ECOSA Field Fit Ditches

1385_20130314_AB_ECOSA Underdrain Modification.pdf

Re: **Modification of ECOSA Underdrain System**

Scale	As shown	East Cresson Overburden Storage Area
Design:	A. Brown, P.E. 22-Feb-2012	PLATE 14
Drawing:	MLE2-Master-35-ECOSA.dwg	SEEPAGE MITIGATION TRENCH SYSTEM
File:	D:\...\1385_cri-mle2\4_Maps

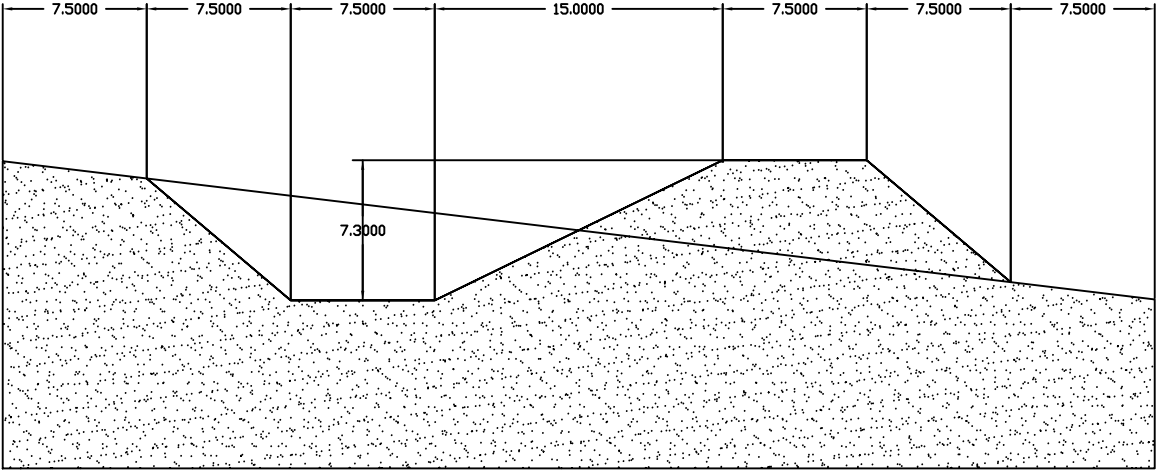
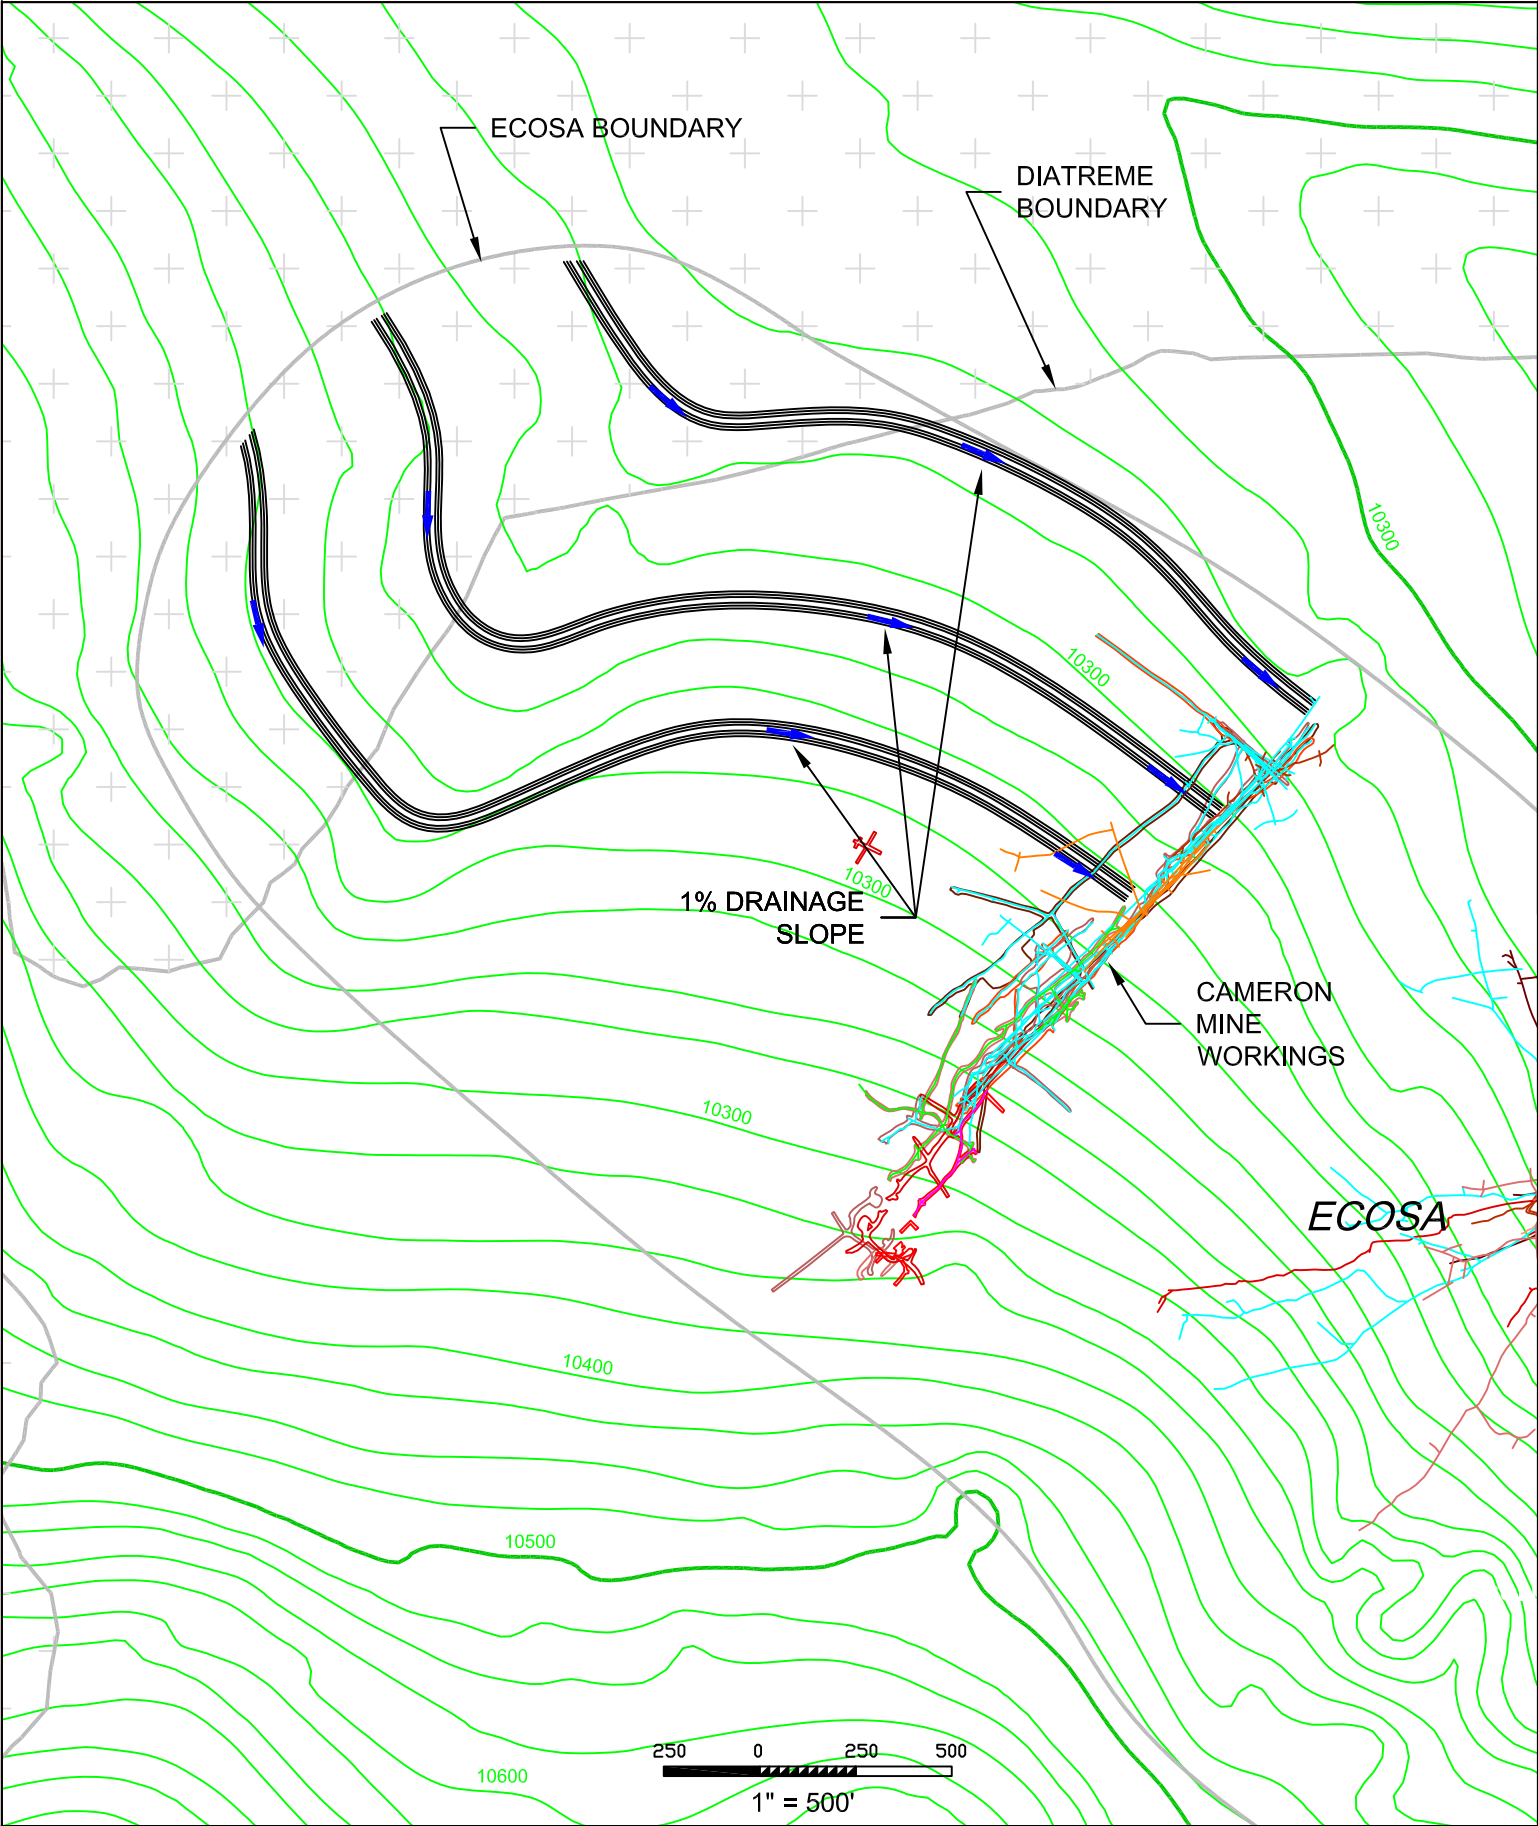
The original underdrain design was included in the Mine Life Extension Permit M-1980-244, and is shown in Plate 14 of the ECOSA design report (Attachment 1 to this letter). The design comprised three parallel 7.3 feet deep seepage mitigation trenches beneath the western half of the ECOSA, whose purpose was to conduct any seepage through the western portion of the ECOSA that overlies Precambrian rock to the east, for infiltration into areas underlain by the drained Tertiary volcanic diatremal rock.

Ecosa Ditch Proposal
3/11/2013

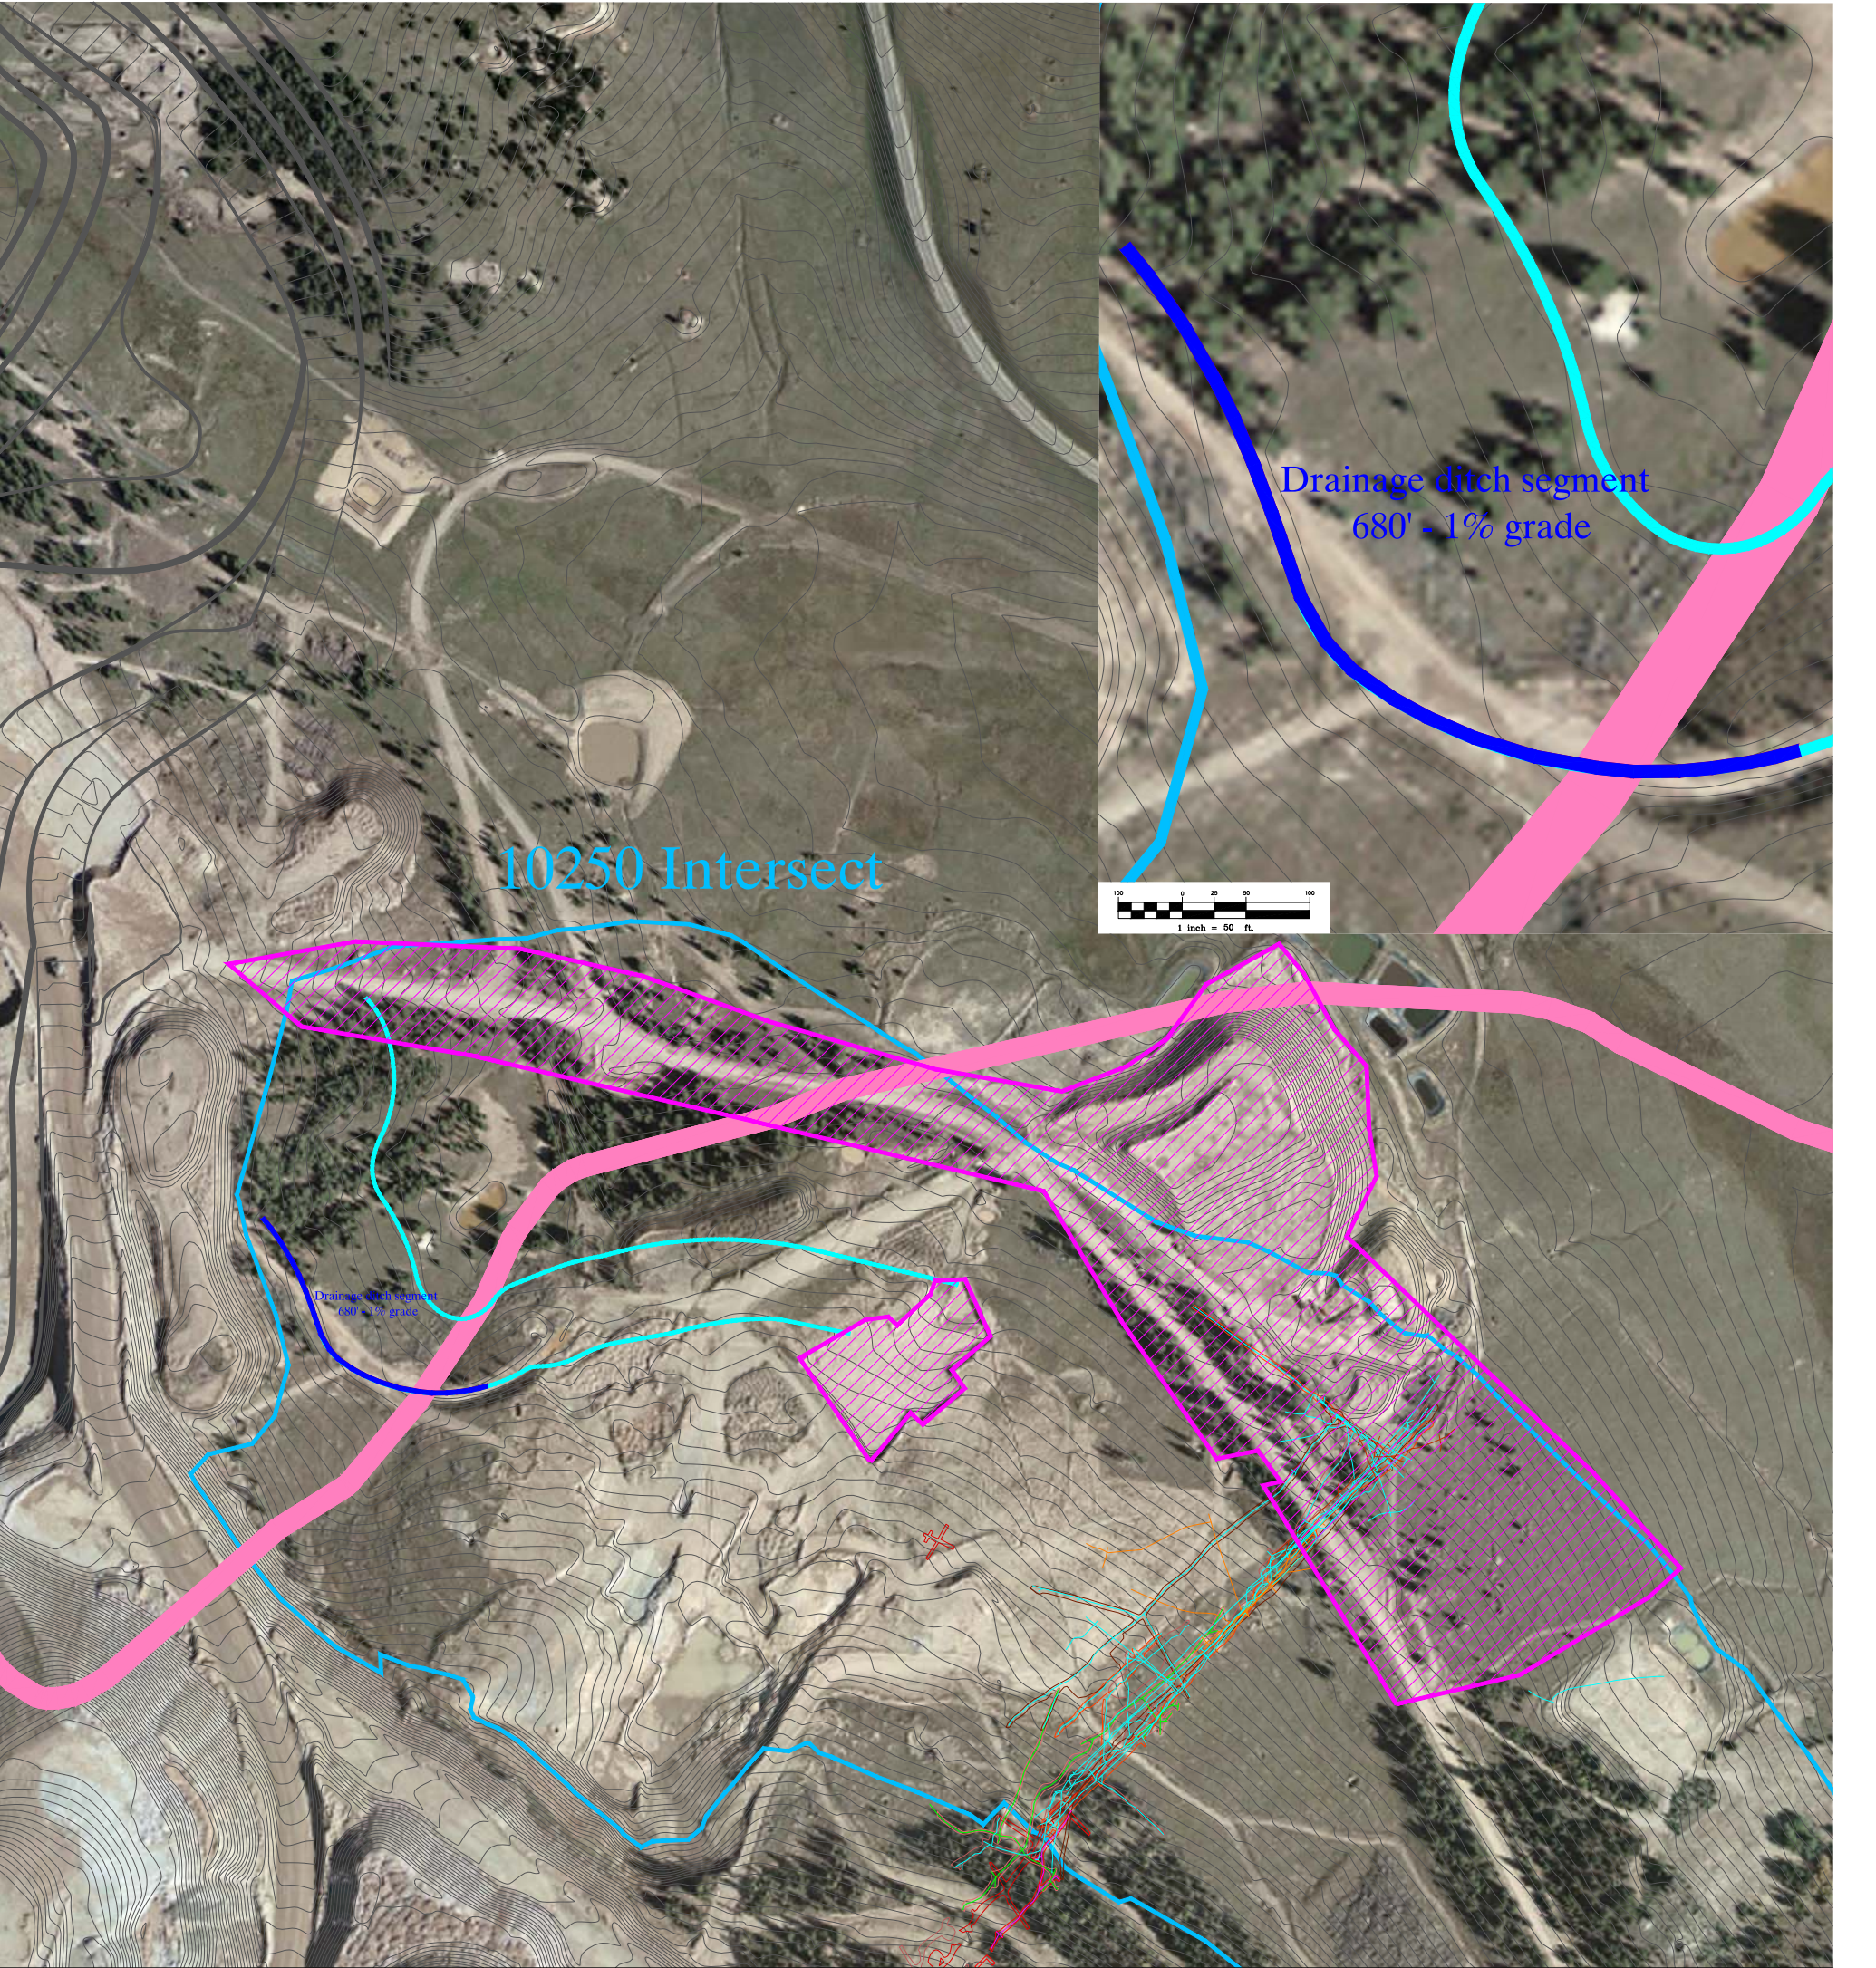
The topography and shape of the ECOSA have changed since the design was undertaken, as a result of mining of clay-rich material from the footprint of the ECOSA, particularly in the western half. Cripple Creek & Victor Gold Mining Company ("CC&V") have proposed a modification to the uppermost (most southerly) seepage mitigation trench to accommodate the changed circumstances, as shown in Attachment 2 to this letter. The southern trench is proposed to start at approximately the original location, and to extend eastward with a 1% downward slope to a clay borrow area in the center west of the ECOSA footprint, where any water contained in the trench will be directed. The trench will not continue beyond the borrow area.

1. Removal of seepage from the Precambrian area underneath ECOSA. The proposed mitigation trench alignment provides drainage from the same area as the original trench, with the same 1% eastward slope, so the drainage capability is unchanged.
2. Infiltration of any captured seepage water to the diatreme rock. The infiltration area of the base of the proposed mitigation trench and borrow area where it discharges that overlies the diatreme is 7,500 square feet in the trench, and up to 90,000 square feet in the borrow pit area. This infiltration area greatly exceeds the 15,000 square feet infiltration area in the original design.

Based on this evaluation, the proposed trench re-alignment is approved.

Following construction of the re-aligned trench, and prior to covering with ECOSA overburden material, the trench shall be inspected by a qualified Professional Engineer, and the opportunity to inspect the trench shall be offered to the Colorado Department of Natural Resources, Division of Reclamation, Mining and Safety.
